UNITED STATES PATENT AND TRADEMARK OFFICE

APPLICATION NO.	FILING DATE	FIRST NAMED INVENTOR	ATTORNEY DOCKET NO.	CONFIRMATION NO.
10/726,760	12/03/2003	Thomas Kocmer	DKT02164	4211

Office Action Summary

DETAILED ACTION

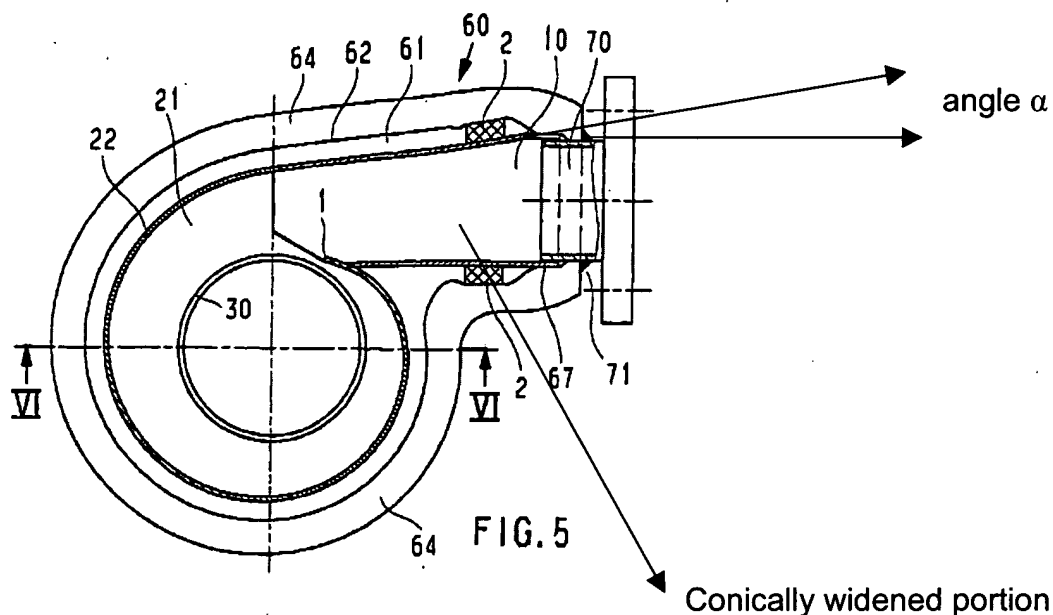
Manfred teaches that it is conventional in the turbocharger art, to utilize said heat conductive connection being formed between first and second tubular elements by a conically widening portion (10) one of the tubular elements, followed by a cylindrical portion into which the tubular end of the respective other element, the tubular connection element (70), inserted, the conically widened portion advantageously having an angle (α) of at most 30° , of at most 20° , and at least 7° and whereby the inner surface the cylindrical portion abuts onto the outer surface of the tubular end of said respective other element, wherein one of said tubular elements is the housing and the other of said tubular elements is the branch pipe (See attached Figures 2, 5, and 11; Column 4, lines 52-58, and Column 5, lines 32-36); and

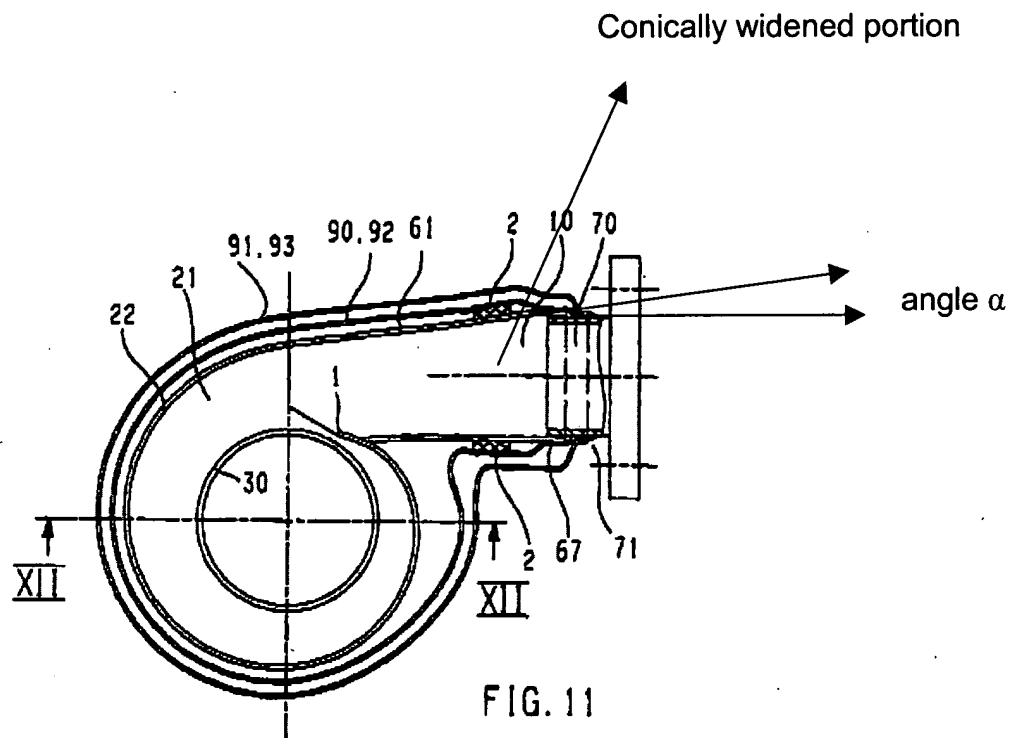
said heat conducting connection comprising a cylindrical portion (See attached Figure 5) of one of the tubular elements, into which the tubular end of the respective other tubular element is insertable, wherein the inner surface of the cylindrical portion abuts onto the outer surface of the branch pipe (70) (See attached Figures 2, 5, and 11; Column 4, lines 52-58, and Column 5, lines 32-36);

said housing (22, 23, 62, 63) consisting at least two layers of metal sheet arranged one outside of the other, wherein the outer one (60, 62, 63) is thicker than the inner one (22, 23) (See attached Figure 5); and
